Notice of Allowability

09/763,312

EXAMINER'S AMENDMENT

Fig. 3

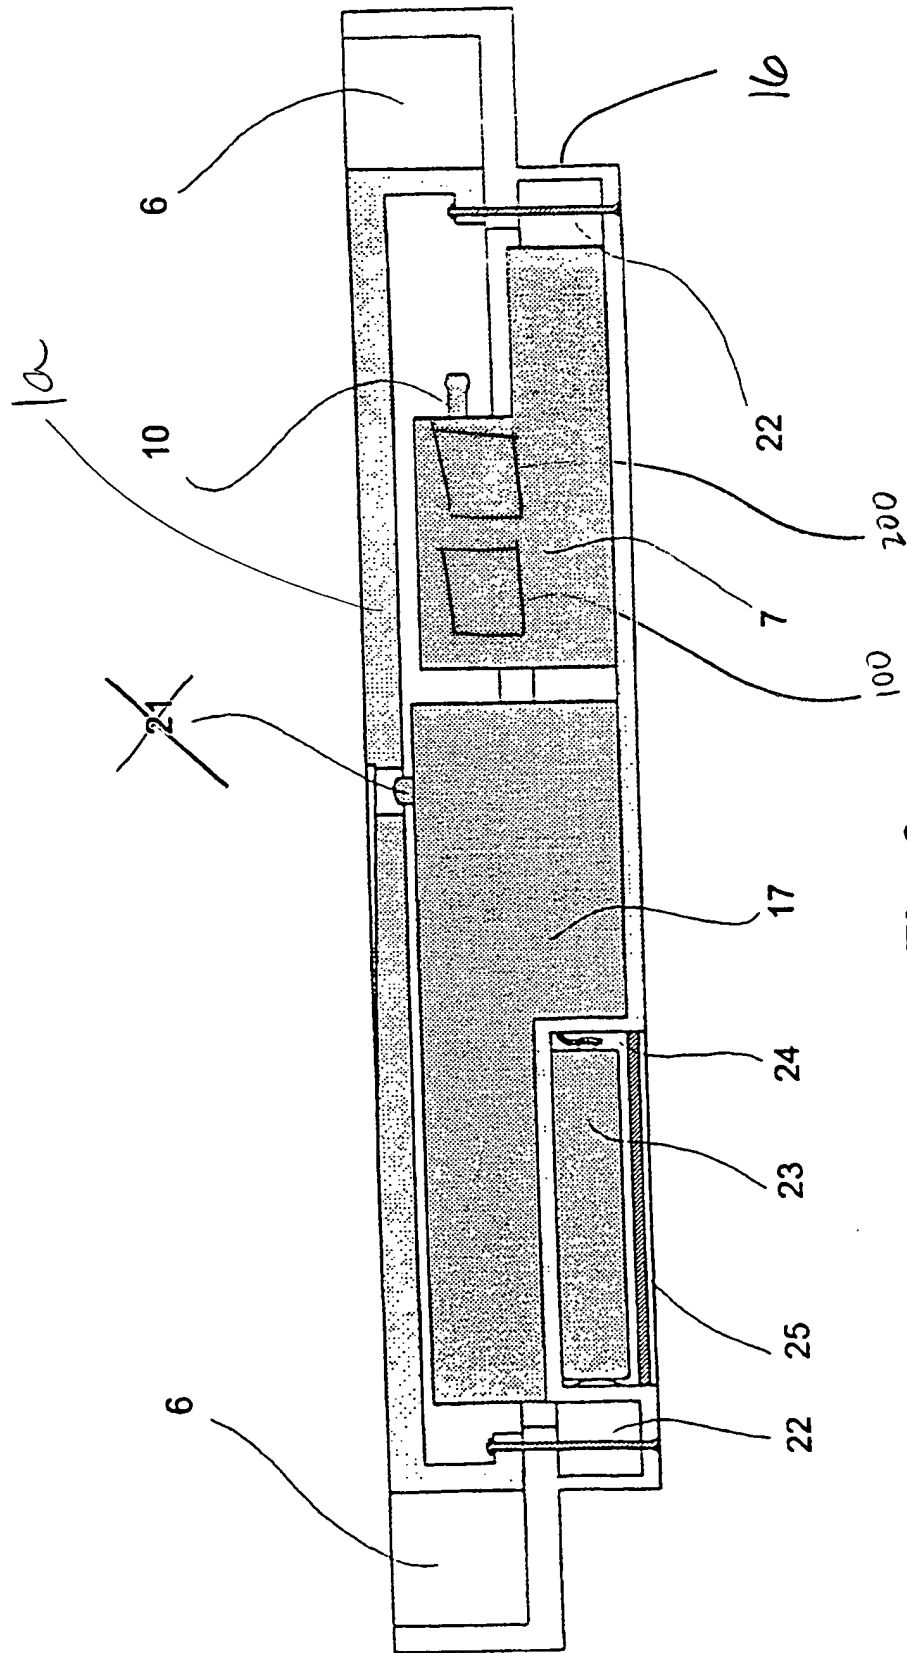
The following changes to the drawings have been approved by the examiner and agreed upon by applicant: Applicant is to insert 2 boxes with reference numeral 100 and 200 respectively in figure 3 in the shades area within the pressure generator unit 7 to show support for claim 10. Reference numeral 21 has been deleted. Reference numeral 16 and 1a has been inserted in fig. 3 to show the first and second portion of the inner casing. See attached proposed figure 3. In order to avoid abandonment of the application, applicant must make these above agreed upon drawing changes.
